Addendum

Subject: Addendum to **Th 9b**, Coastal Commission Permit Application

#6-06-146 (UCSD), for the Commission Meeting of 6/14/07

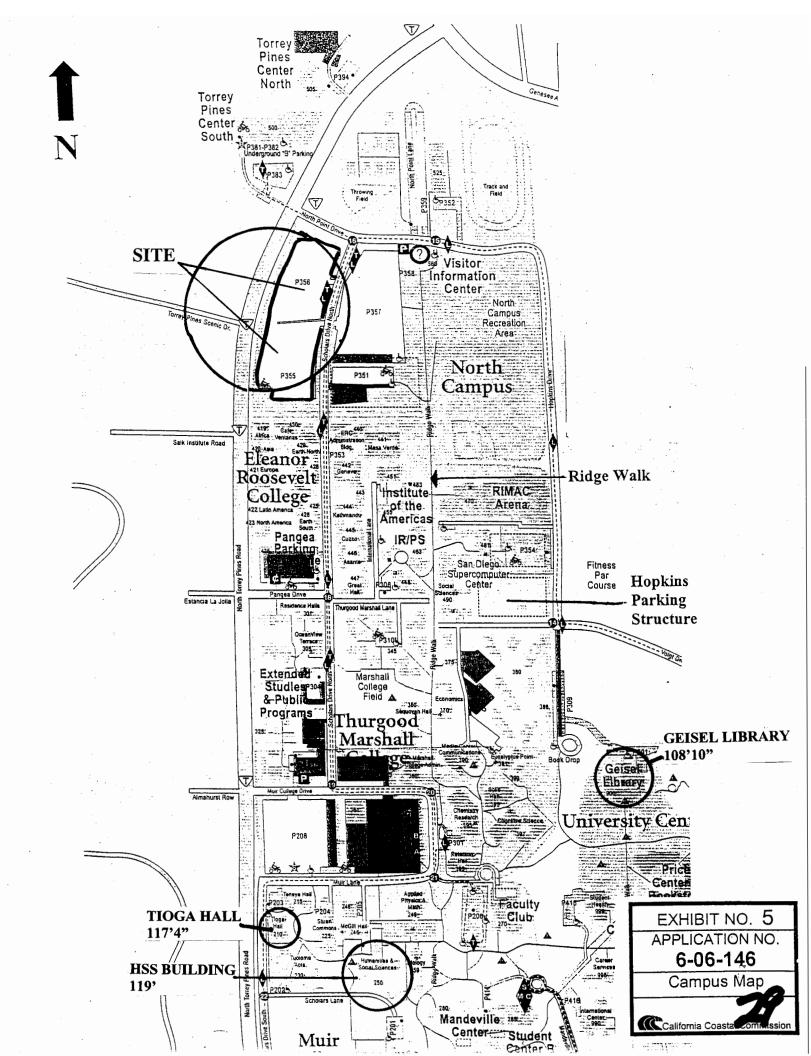
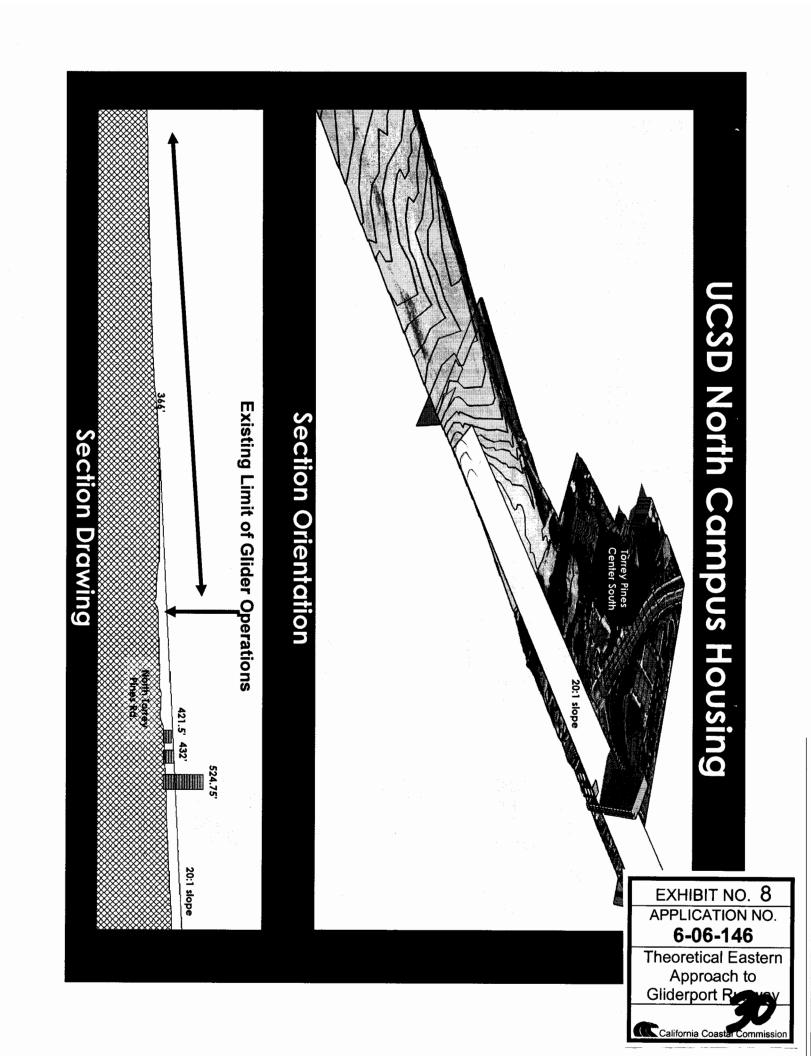
- 7. Exhibit No. 5 has been revised (attached) to show the three other campus structures in the vicinity of the project site which exceed 100 ft. in height.
- 8. The following two exhibits of the "theoretical" east approach for the gliderport flight path in relationship to the proposed North Campus Housing project shall be added as Exhibit Nos. 8 and 9 to the staff report.
